TRUCK, CARGO, LIGHT, MC2 - LAND ROVER 110 6X6
TRUCK, CARGO, LIGHT, WINCH, MC2 - LAND ROVER 110 6X6
TRUCK, AIR DEFENCE, LIGHT, FFR, MC2 - LAND ROVER 110 6X6
TRUCK, AMBULANCE, LIGHT, 4 LITTER, FFR, WINCH, MC2 - LAND ROVER 110 6X6

FITMENT OF CENTER SEAT BACK RUBBER BLOCK

MODIFICATION INSTRUCTION

FIG 1 - RUBBER BUFFER MOUNTING DETAILS

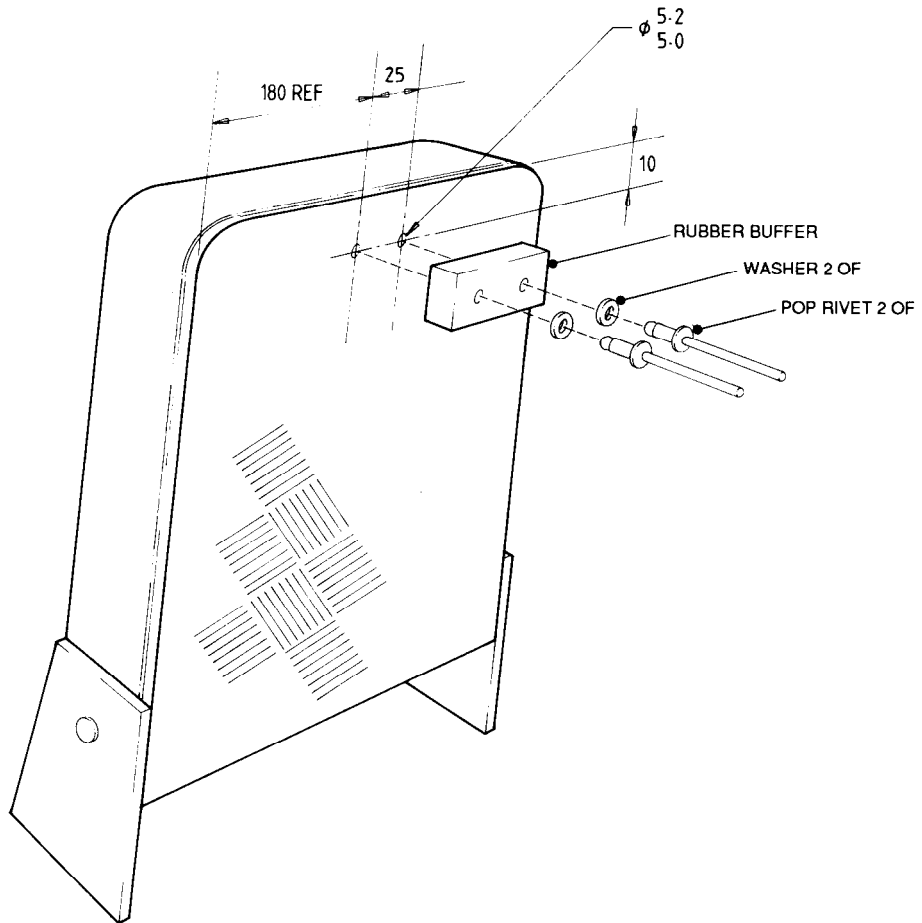
1. This instruction details the fitment of a rubber buffer block to the rear of the center seat to prevent abrasion of the cab trim when the seat is fully rearwards. The modification only affects ISRI brand seats (labelled on plate near seat frame back rest hinge point).

- a. Fold down the center seat.
- b. Mark and drill the holes as shown in Fig 1.

1. Ensure that the cushion is pulled away from the tread plate to prevent damage to the cushion material when the drill penetrates the tread plate.

- c. Fit the rubber buffer (item 1 from Table 2) to the tread plate using the pop rivets and washers (items 2 and 3 from Table 2).
8. Modification Record Plate. Deface the numeral 12 on the modification plate located on the driver's seat base, including the vehicles modified in production.
9. Recording. Enter the details of the modification in Part 3 of the TGM 120, Record Book for Service Equipment, for the subject vehicles, including the vehicles modified in production.
